Whitehead & Associates  
Environmental Consultants

Peter Shipway  
c/- Lisa Wrightson  
Barker Ryan Stewart  
Re: 4 Henstock Road,  
Arcadia NSW 2159  
(via email)

Ref: 2959\_RFI letter

## **Details of existing on-site sewage management system at 4 Henstock Road, Arcadia**

**Figure 1: Site Plan Showing Existing OSSM**

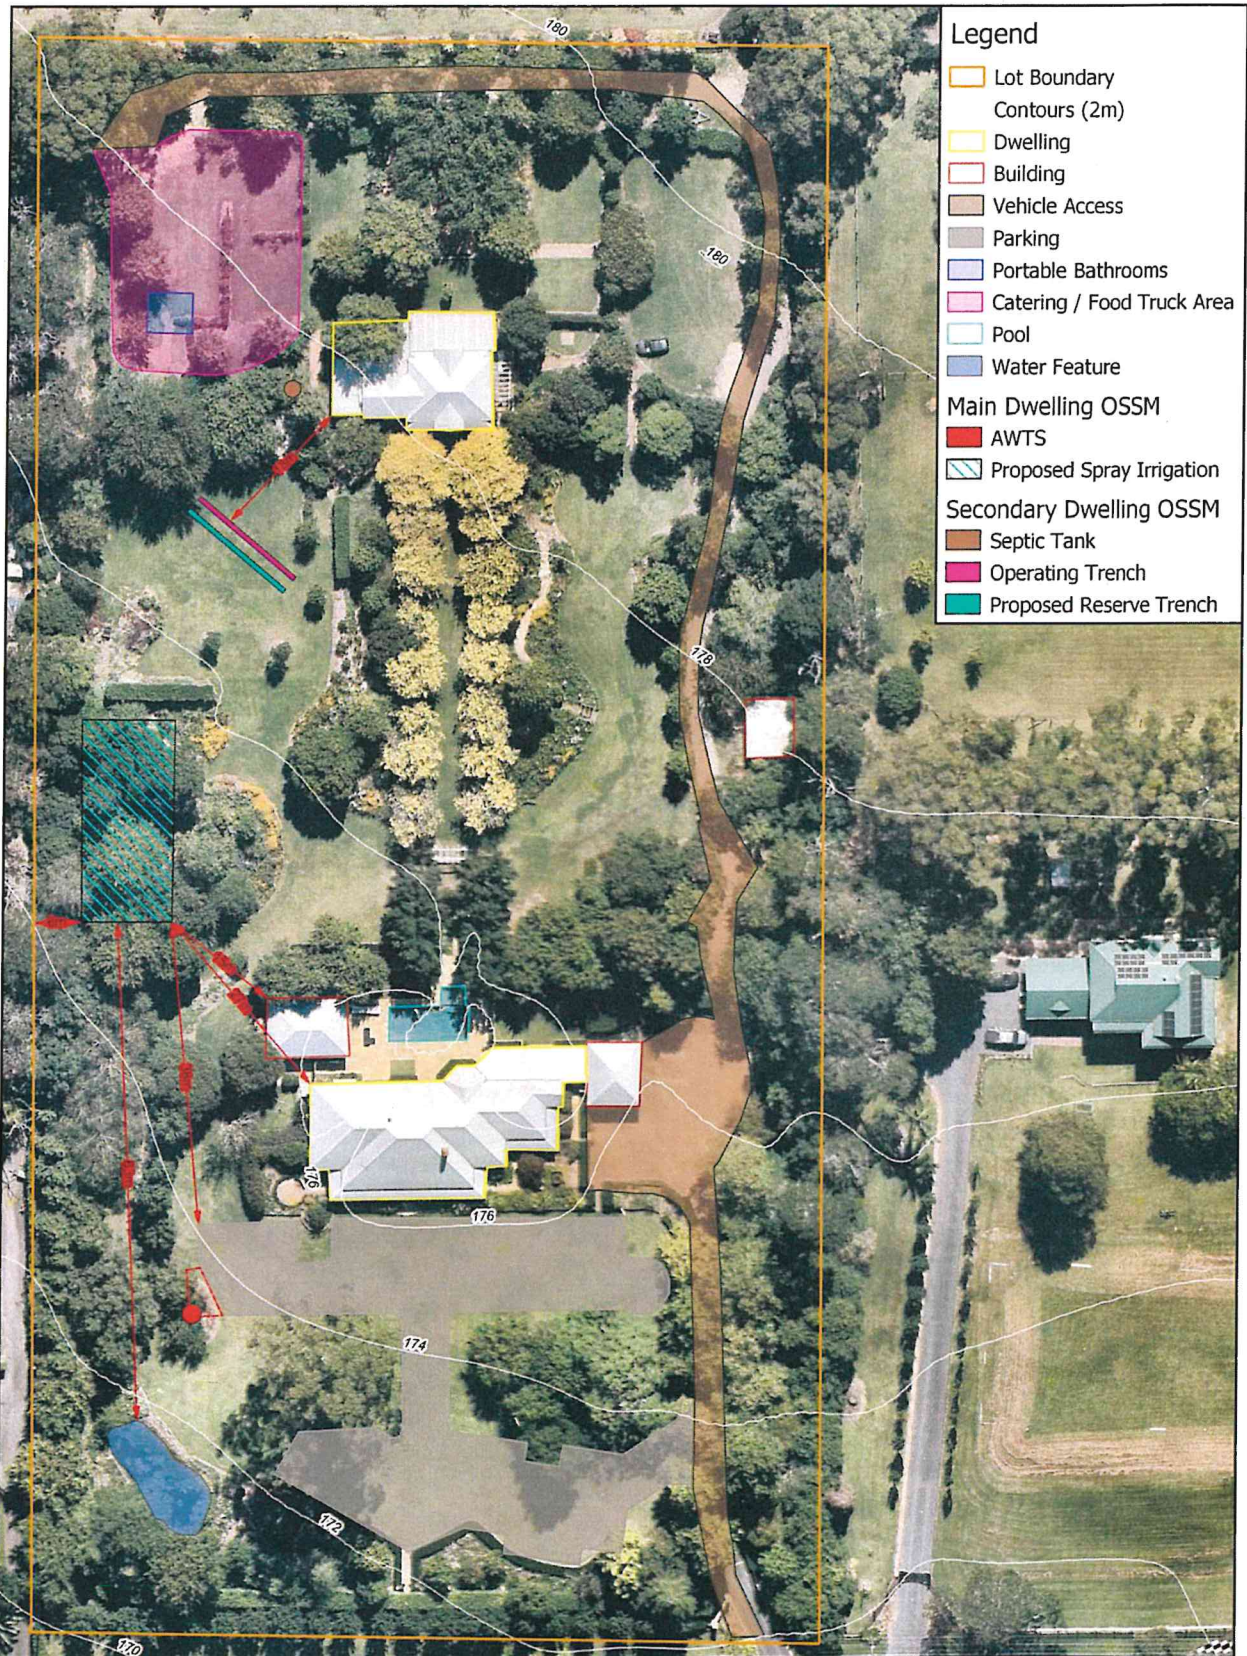
Plans provided show that the DA includes the provision of car parking in the front area of the property, within close proximity to the existing spray irrigation land application area (LAA) servicing the main dwelling. This has been flagged by Council as a potential contact risk, prompting the request of the following information.

*The proposed car parking conflicts with the AWTS location (refer Figure 1 of Appendix A). Relocation of the AWTS is problematic; therefore, it is recommended that the proposed car parking layout is amended to resolve this issue. Further, to comply with AS1546.3:2017, a physical barrier or buffer should be provided between trafficable areas and the AWTS. A nominal buffer of 2m is provided by the garden area surrounding the tank (refer Figure 2 of Appendix A).*

Secondary (disinfected) effluent is spray irrigated to a ~155m<sup>2</sup> LAA installed within a landscaped (garden) area near the southern property boundary, east of the driveway access (refer Figure 1, Appendix A). Distribution is achieved via multiple (wobbler) sprinkler heads installed on ~1m risers.

It is understood the original (s.68) approval for this system required 300m<sup>2</sup> of LAA be provided for surface irrigation. It appears the LAA has been reduced over time as a result of re-location. No signage informing effluent reuse was observed. DLG (1998) recommend a minimum setback of 6m be applied between 'surface spray irrigation' areas and driveways. Council have requested a setback of >15m is applied to car parking areas.

*The existing spray irrigation LAA is located directly south of the proposed car parking area, with no available setback (refer Figure 1 of Appendix A). This does not comply with the Council specified setback requirement (15m); therefore, the LAA should be relocated.*

The layout of the OSSM system servicing the secondary dwelling has been presented in Figure 1 of Appendix A. There are no upgrades to this OSSM system proposed under the DA.

*It is recommended that the LAA be re-instated to 300m<sup>2</sup>, as per the original OSSM approval.*

*Due to the proposed (visitor) use, the LAA should be fenced or otherwise access-restricted. A minimum of two (2) warning signs, complying with AS1319:1994, should be installed to inform patrons that effluent reuse is occurring.*

*A proposed location complying with the specified setback criteria is shown in Figure 2 of Appendix A.*

*A nominal location for a suitable reserve area is presented in Figure 2 of Appendix A.*

- The existing AWTS is appropriate for continued use, with ongoing regular servicing by a licensed provider;
- Secondary treated (and disinfected) effluent should be irrigated to a newly located 300m<sup>2</sup> LAA, complying with minimum Council buffers, as shown in Figure 2 of Appendix A; and
- The DA plans should be amended to remove conflict between the car parking area layout and recommended setbacks to the fixed AWTS location.

- The existing (3,000L) septic tank is appropriate for continued use, considering both the residential and event uses proposed;
- The septic tank should be fitted with an effluent outlet filter;
- Primary effluent shall continue to discharge to the operating trench, which should be 'staked out' or otherwise marked, such that its location can be identified on the surface;
- Inspection and maintenance servicing of the OSSM should be added to the existing servicing contract for the main dwelling OSSM system;
- The existing 'reserve trench' should be abandoned-in-place; and
- A new 'reserve area' is to be identified at the Site, with this area to remain set-aside from future development.
